SUNOL TRIPLEX

SITE PLAN REVIEW

PERMIT #: RPPL2021012599

Permit: RPPL2021012599	Project No.: PRJ2021-004401	EXPIRES: 08-02-2024
Address: 120 S Sunol Drive, Los Angeles CA 90063		APN: 5233028006
Approved by: Jeantine Nazar	Zone: SP-LMD	Approved on: 08-02-2022

1 Site Plan
3/32" = 1'-0"

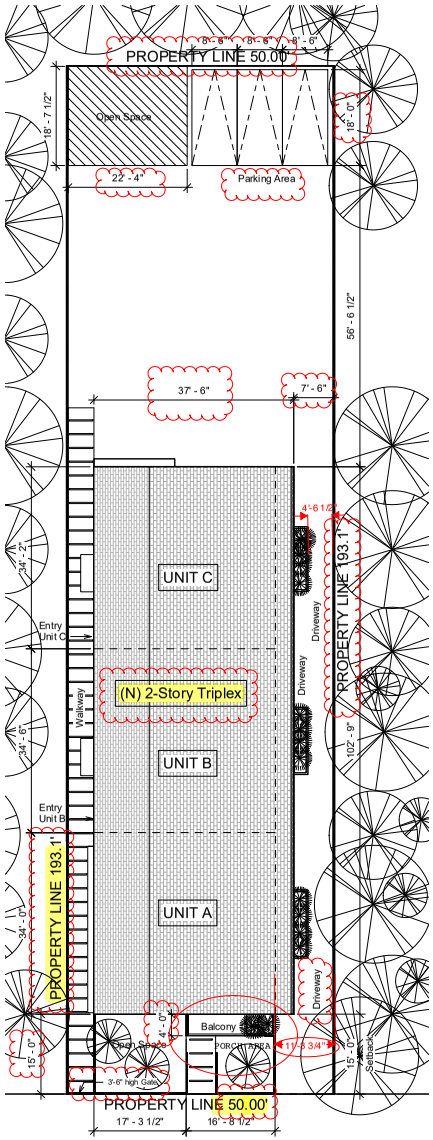
This Ministerial Site Plan Review approves the above-referenced project:
A (n) 2-story 6,289 sq. ft. triplex with 3-car detached open parking at the rear in the East Los Angeles Specific Plan within the LMD Transect Zone, as shown. Comply with the following approval standards:

- Demolish the existing 760 sq. ft. single-family dwelling and the detached garage built in 1913.
- Construct a new 2-story triplex to include Yard/Porch frontage and Triplex Building Type per East LA Specific Plan. Units have 5 bedrooms and 3 bathrooms, each with laundry rooms inside the units consisting of Unit A: 2,125 sq. ft., Unit B: 2 142 sq. ft., and Unit C: 2,022 sq. ft.

- Design. The Design Review Committee provided comments on February 24, 2022, and the applicant revised the plans accordingly.
- The proposed front porch is 8'-0" in depth and covered by a 4'-0" balcony, 4'-0" overhang, 15'-9" wide, and more than 8 feet in height open on three sides with a clear floor area exceeding 48 sf and depth of travel min 3 feet wide comply with the ELA SP Front Yard/Porch requirement of 2.2.4 f.0.13 D.D.

- The Triplex Building design complies with the standards by providing a single-family type composed of a house form, an open space at the rear, three 36-inch canopy trees, and individual entries, one facing the street.

- The project complies with the Low Medium Density (LMD) requirements by proposing a 2-story building less than 35 feet in height and less than 60 percent coverage.

- Setbacks. Required 15 front, 5 sides, and 10 rear. Proposed: 15-front, 5-7 sides and more than 10 feet rear. Open space provided as required.
- Projections. Balconies may project a maximum of 2 feet into the side and 4 feet into the front yard. Overhangs on the side may project 2 feet into the side setbacks. Proposed and Satisfied

- Height. Maximum allowed 35 feet. Proposed 32'-4" feet above the grade level, excluding chimneys, rooftop antennas, mechanical equipment and structure-mounted renewable energy systems

- Parking. The required parking is one space per dwelling or a total of three spaces.
- Dimensions. Minimum standard 8.5 feet X 18 feet per stall.
- Driveway. Maintain 10 feet minimum driveway

- Back up. Minimum 26 feet.
- Setback. Rear 0 ft min

Approval Notes P. 2
Tree Planting. A minimum of two 15-gallon trees are required per the Tree Planting ordinance-additional three 36-inch canopy trees per ELA SP plan for a total of five trees. Comply with the drought tolerant landscaping requirements.
- Fences/Walls/Gates. Maximum allowed 6 feet side/rear yards and 42 inches in the front yard.
- Metal materials used on the roof and facades shall not be reflective, glossy and polished
- Grading. None is proposed or approved.
- Oak Trees. None are indicated to be onsite. Approval does not grant any impact on oak trees.
- Green Building and LID requirements may apply to the satisfaction of the Department of Public Works.
- Obtain building permits.
